Contract No. T201007101.01
Federal Aid Project No. T201007101
BR 1-404 ON N427 CEDAR LANE, MIDDLETOWN
New Castle County

Enclosed is Addendum No. 1 for the referenced contract consisting of the following:

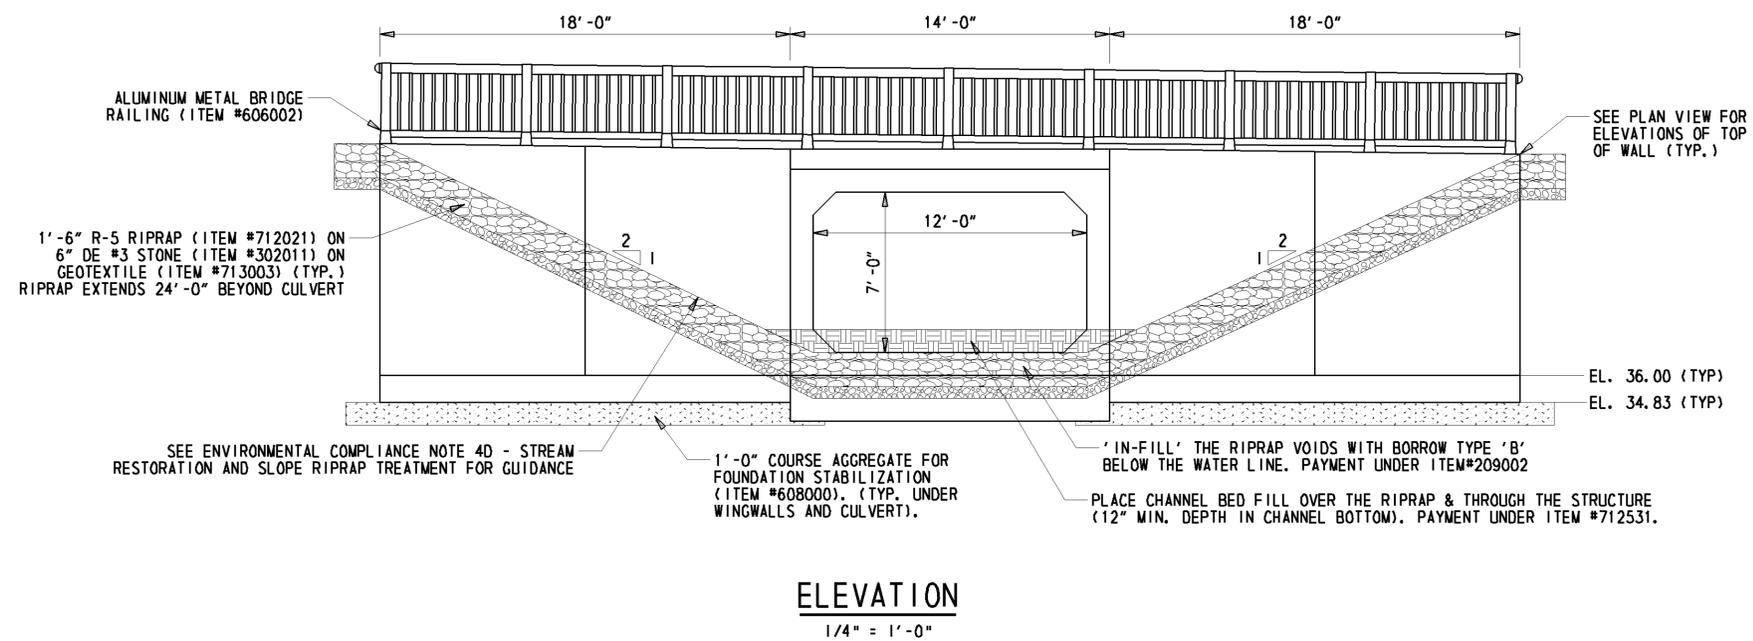
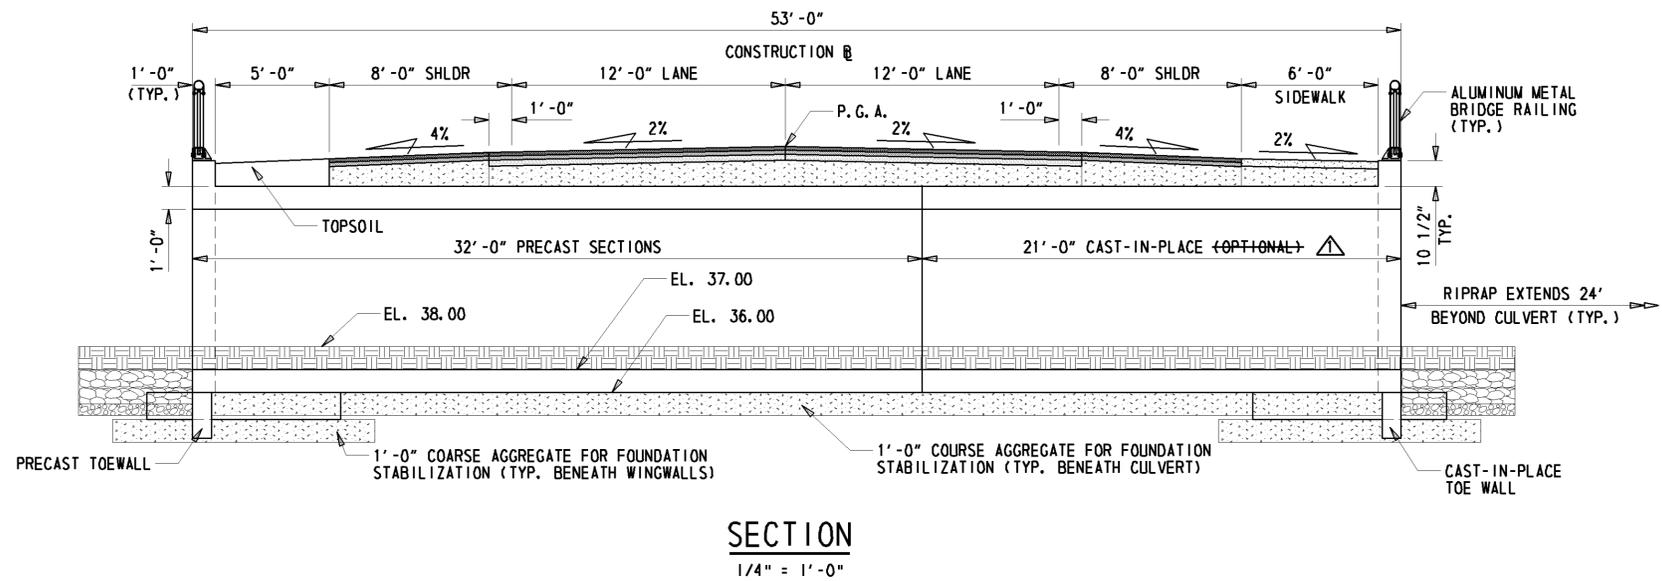
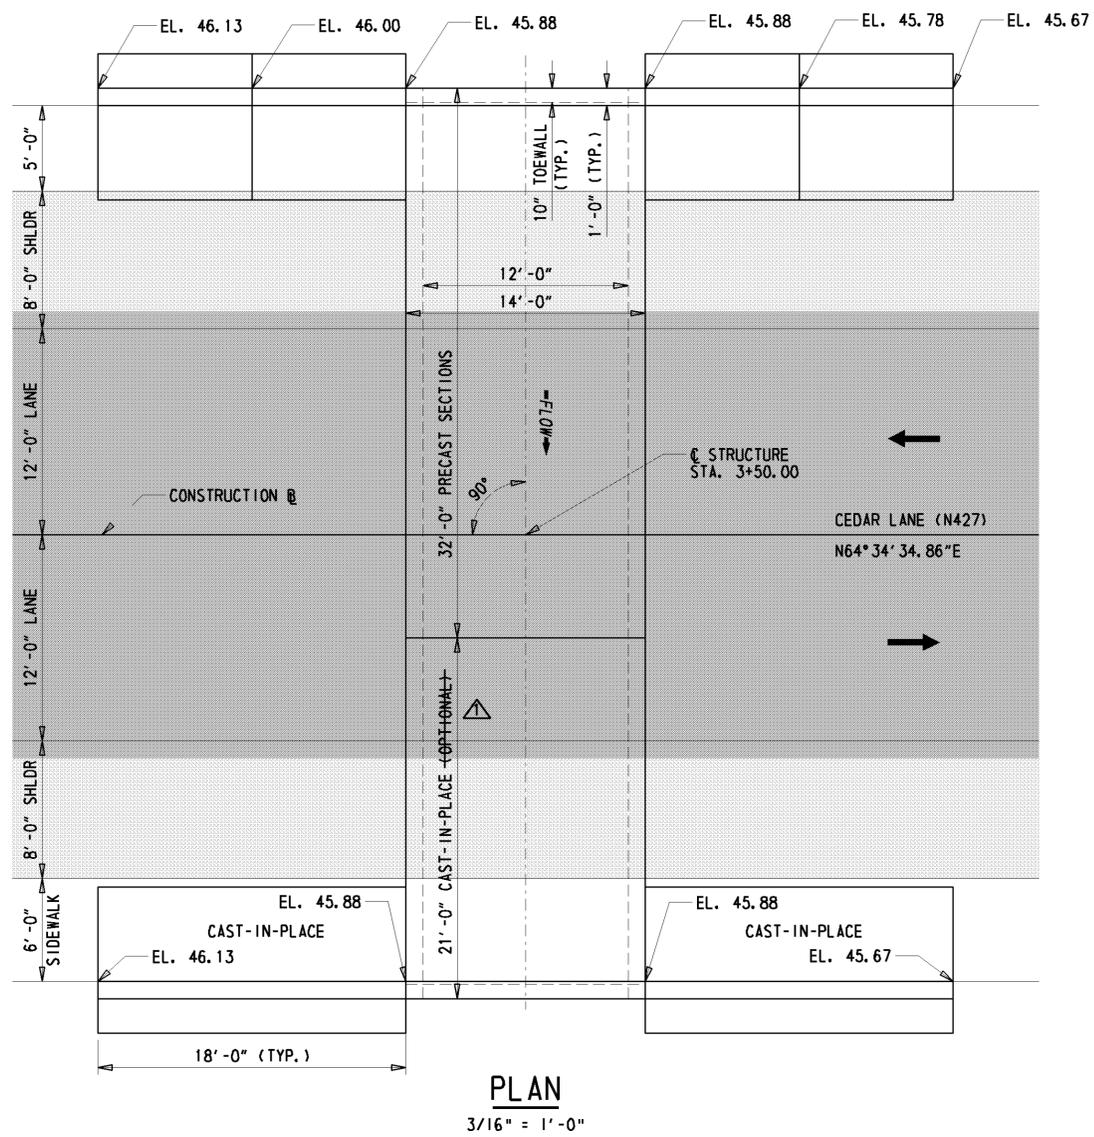
1. Plan sheet number 7 indicates that the cast-in-place portion of the culvert is optional. Is this correct? The bid form does not seem to be setup for bid options.

THE PROPOSED BRIDGE SHALL BE CONSTRUCTED WITH THE EXISTING AERIAL UTILITY LINES IN PLACE AND IN SERVICE DURING CONSTRUCTION. SEE THE UTILITY STATEMENT FOR MORE INFORMATION ABOUT THE EXISTING FACILITIES AND CLEARANCE THAT MUST BE MAINTAINED DURING CONSTRUCTION. THE PORTION OF THE BRIDGE BENEATH THE AERIAL LINES WILL NEED TO BE CONSTRUCTED USING CAST-IN-PLACE CONCRETE AS DETAILED ON THIS SHEET.

Answer: The word optional has been removed from the plan sheet # 7 and please see attached addendum # 1.

<p>DELAWARE DEPARTMENT OF TRANSPORTATION</p>	ADDENDUMS / REVISIONS		<p>BR 1-404 ON N427 CEDAR LANE, MIDDLETOWN</p>	CONTRACT	BRIDGE NO.	<p>BR 1-404</p>	<p>BRIDGE PLAN, SECTION & ELEVATION</p>	SHEET NO.
	<p>△ REMOVED 'OPTIONAL'</p>			T201007101	DESIGNED BY: KRL			7
				COUNTY	CHECKED BY: BAB			TOTAL SHTS.
				NEW CASTLE				19
